SB, 346, 351, Crankcase, 2002-06

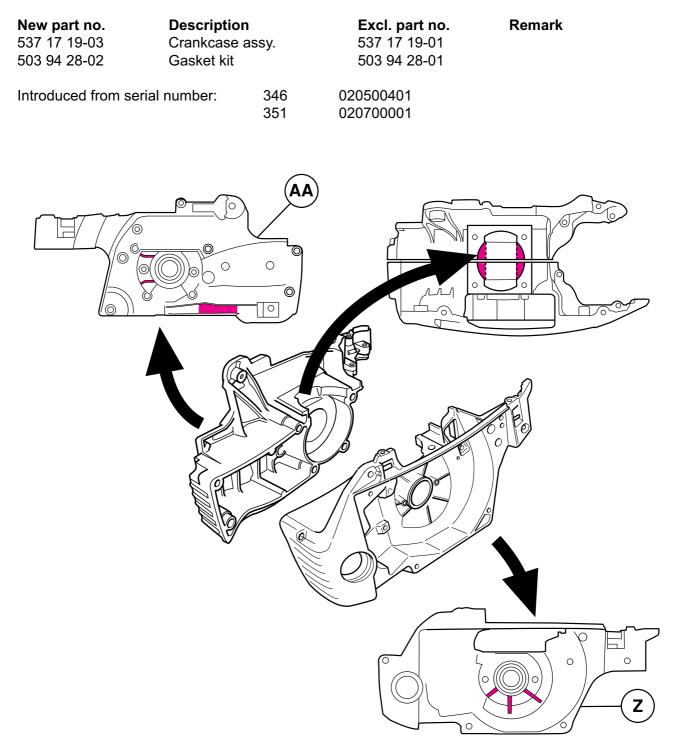
The crankcase has been reinforced and modified.

The crankcase has the following casting codes: clutch side AA, flywheel side Z.

The crankcase gasket has also been replaced, and the part number of the gasket kithas therefore changed.
